Our Ref: 17068
Council Ref: SSDA 8517 & SSDA 8449

RE: SSDA 8517 and SSDA 8449 - Response to Request for Further Information

This letter has been prepared on behalf of Mirvac Projects Pty Ltd (Mircvac) to respond to the issues raised by the Department of Planning and Environment (Department) and other key stakeholders following their assessment of the Response to Submissions (RTS) reports submitted to the Department in support of SSDAs 8517 and 8449. A Response to each of the issues raised is set out below.

Figure 1 Loading Dock manoeuvring constraints

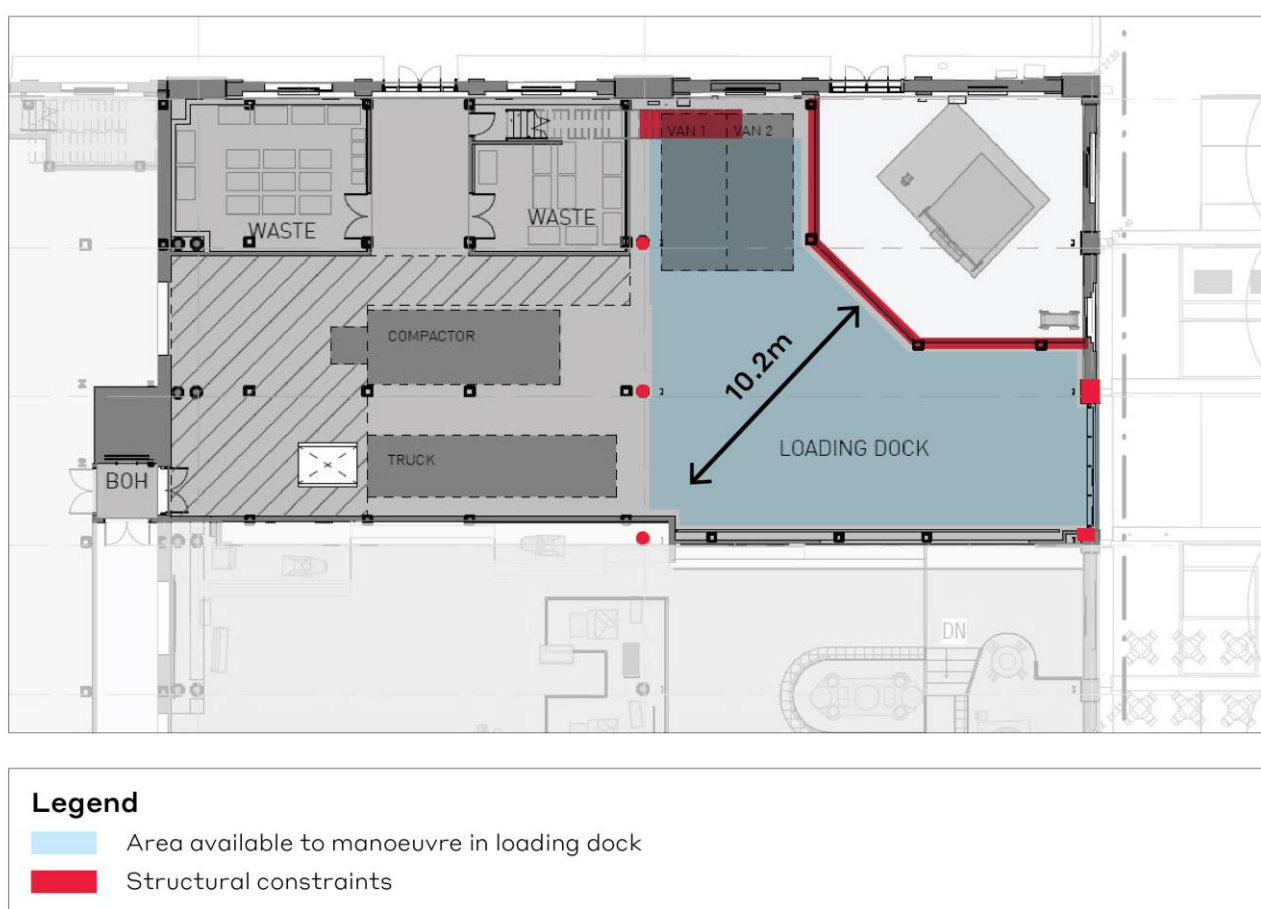
Demonstrate how trucks can enter the loading dock from Innovation Plaza in a forward direction and exit in a forward direction (with all reversing movements occurring within the loading dock).

The proposed design of the loading dock does not allow the proposed 10.2m long trucks to enter and exit the loading dock in a forward direction from Innovation Plaza. The swept path plans submitted with the RTS Report for SSDA 8517 illustrated that service and waste vehicles can exit the loading dock in the forward direction but must reverse to enter from Innovation Plaza.

The analysis has found that the area for manoeuvring vehicles within the loading dock is significantly constrained by the proposed access stairs located adjacent to the northern wall above the van parking spaces; the glass barrier that surrounds and protects the Davy Furnace; the size of the loading dock door and the existing heritage columns, as identified within **Figure 1**. Accordingly swept path assessments have indicated that in order for trucks to complete the three-point turn necessary when entering in a forward gear, the following would occur:

- the 10.15m Large Rigid Truck would conflict with the access stairs above the van spaces, conflict with the Davy Furnace barriers and reverse in very close proximity to the heritage columns. Due to the location of the heritage columns and the loading dock doorway, extending the loading dock wall further south towards the Davy Furnace would not improve the manoeuvrability of the trucks;
- the 10.2m Refuse Collection Truck would need to undertake a 5-point turn and rely on the van parking spaces being unoccupied. Furthermore, there would be a high chance of the trucks colliding with the Davy Furnace barriers, the access stairs above the van spaces and heritage columns. Repositioning of the loading dock wall would also not improve the manoeuvrability of the trucks.

Figure 2 Existing service access route

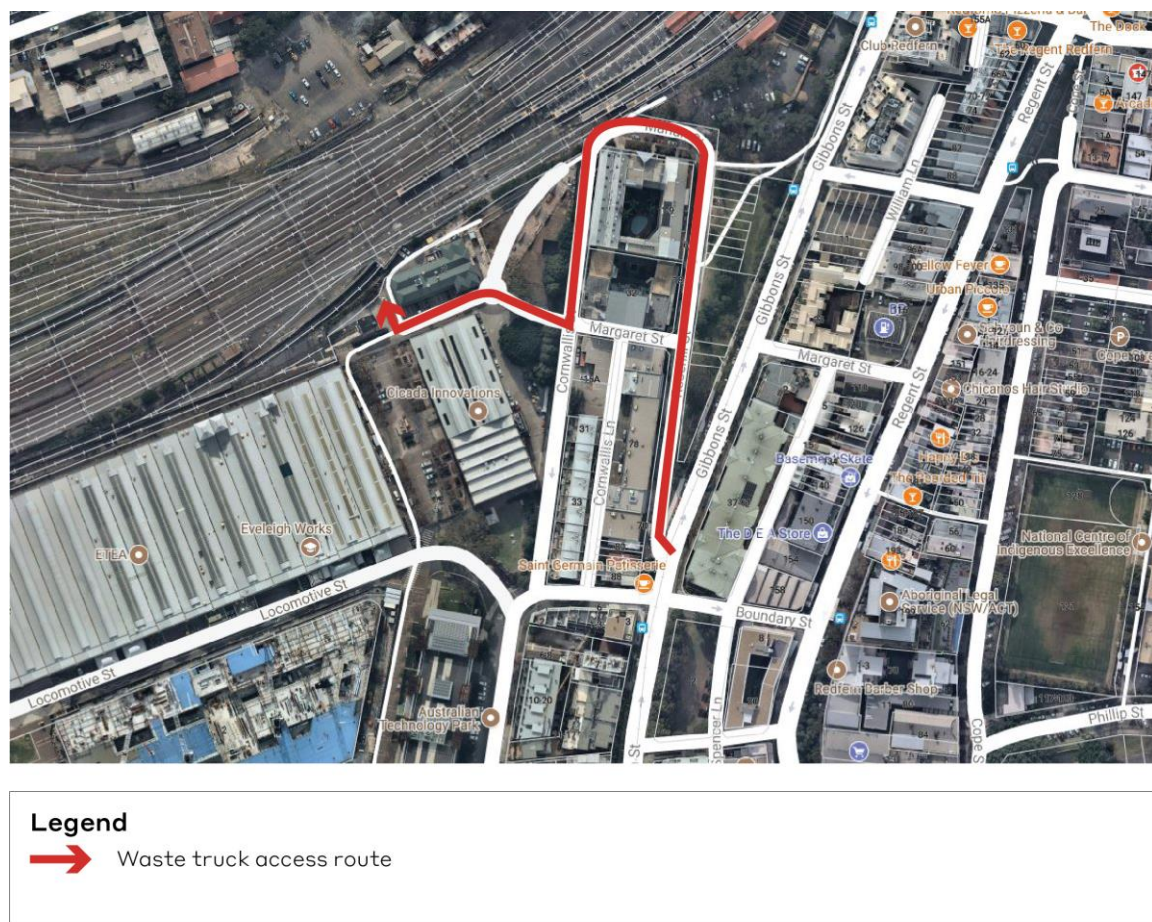
Advise how waste trucks (i.e. route and length of truck) currently access the refuse area located north of Innovation Plaza.

At present, Refuse Collection Trucks that service the Locomotive Workshop have an overall length of 8.0m and service the site 3 times per week. The trucks enter the ATP site from the northern access off Cornwallis Street at the junction with Margaret Street and then drive between the IBA Building and the NIC Building, before turning into Innovation Plaza and reversing to the waste storage compound located to the north of Innovation Plaza and adjacent to the rail line (refer to **Figure 2**). Staff within the Locomotive Workshop transfer their own waste to the waste storage compound.

The existing waste storage compound is not suitable to accommodate the significant additional quantity of waste that will be generated by both the commercial tenants and the retail operators by the Locomotive Workshop redevelopment. It has been demonstrated within the EIS and the Waste Management Plan Report that the proposed volume and different waste streams can be effectively managed, sorted and stored within the loading dock.

Figure 3 Proposed extension of the Rosehill Street parking restriction area

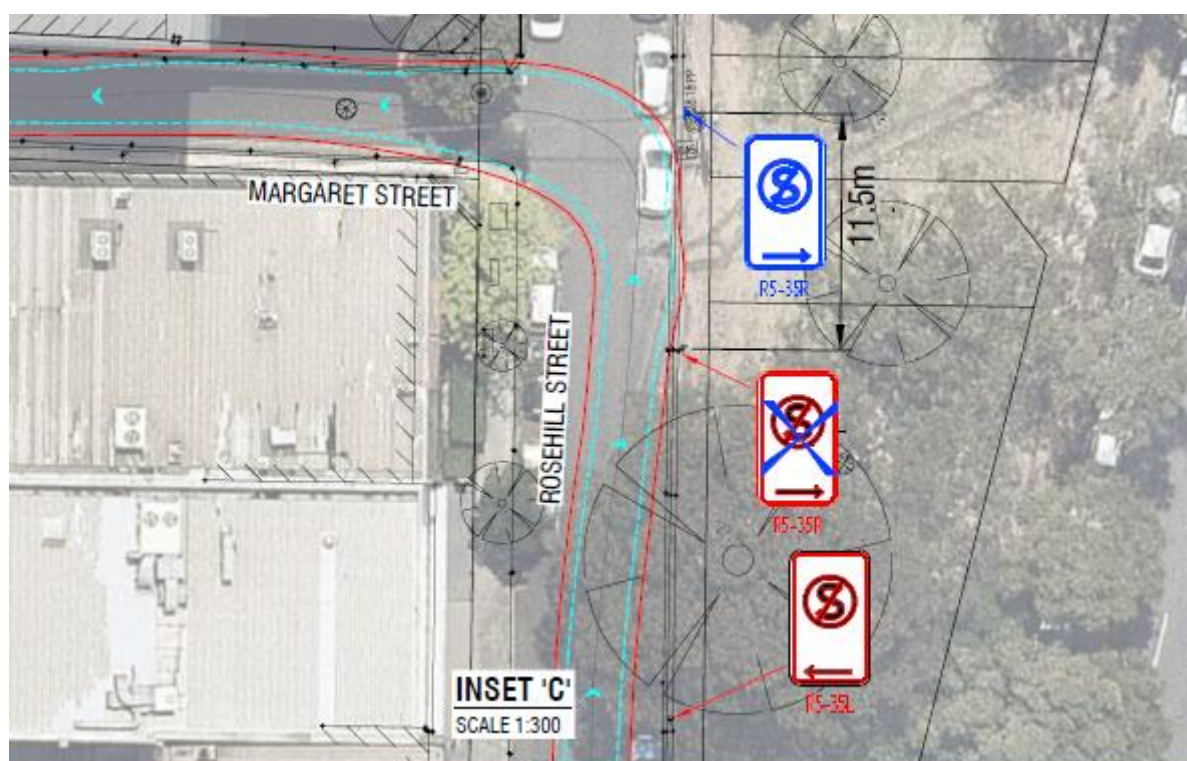
It is the City's preference that the service vehicle travel route should exclude the Shared Zone on Marian Street. If Option 1 via Rosehill Street and Margaret Street is pursued, as stated in previous correspondence, any changes to the existing road network will need to be referred to the Local Pedestrian and Traffic Calming Committee for endorsement and the applicant bears the risk that works may not be endorsed.

Mirvac's preference is to utilise Option 1 – the Rosehill Street- Margaret Street-ATP site and will work with the Local Pedestrian and Traffic Calming Committee to seek endorsement for the 11.5m-12m extension of the current Rosehill Street 'No Stopping' parking restriction near Margaret Street.

To clarify, this extension would only require the relocation of a single signpost and would result in the loss of two on-street car spaces as illustrated in **Figure 3**. No other changes to Rosehill Street or Cornwall Street would be required.
